# Wisconsin Department of Transportation

**Proposal #21: 1166-00-79, WISC 2020 078**  
**Stevens Point - Wausau**  
**N 2<sup>nd</sup> St to CTH X**  
**IH 39**  
**Portage County**

This is Addendum No. 01, which provides for the following:

**ADDENDUM NO. 01**

Addendum No. 01  
ID 1166-00-79  
Revised Sheet 11  
February 24, 2020

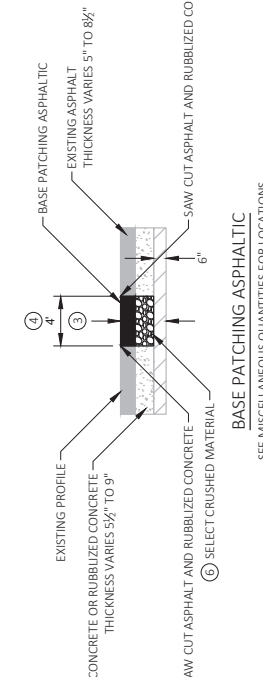
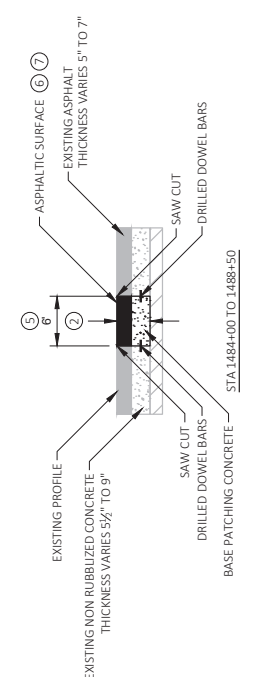
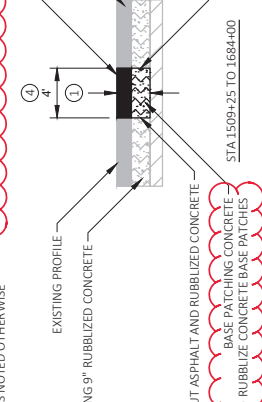
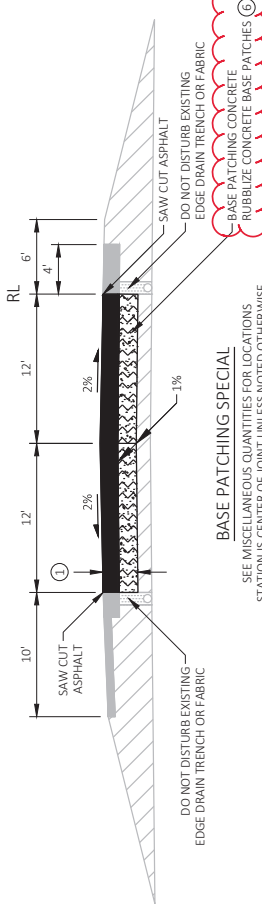
Revised Plan Sheets	
Plan Sheet	Plan Sheet Title (brief description of changes to sheet)
11	Construction Detail - Added note to rubblize concrete base patches and option for full depth base patching concrete.

NOTE: COMPLETE BASE PATCHING SPECIAL AND BASE PATCHING ASPHALTIC PRIOR TO PAVING

- ① CONCRETE: 9" ASPHALT: 8½" AT CENTERLINE, 7" AT EDGELINE SB: STA 1510+50 - STA 1604+00 SB: STA 1620+00 - STA 1684+00
- ② CONCRETE: 9½" TO 9" MATCH EXISTING CONCRETE THICKNESS ASPHALT: 5" TO 7" SB: STA 1484+00 - STA 1488+50
- ③ SELECT CRUSHED MATERIAL 5½" TO 9" MATCH EXISTING CONCRETE OR RUBBLIZED CONCRETE THICKNESS ASPHALT: 5" TO 8½" MATCH EXISTING ASPHALT THICKNESS
- ④ IF SPACE BETWEEN CONSECUTIVE PATCHES IS 6' OR LESS, REMOVE CONCRETE OR RUBBLIZED CONCRETE BETWEEN PATCHES
- ⑤ 6' LONG BASE PATCHING SPECIAL UNLESS NOTED OTHERWISE
- ⑥ INCIDENTAL TO BASE PATCHING SPECIAL OR BASE PATCHING ASPHALTIC MAY USE BASE PATCHING CONCRETE IN LIEU OF ASPHALTIC SURFACE
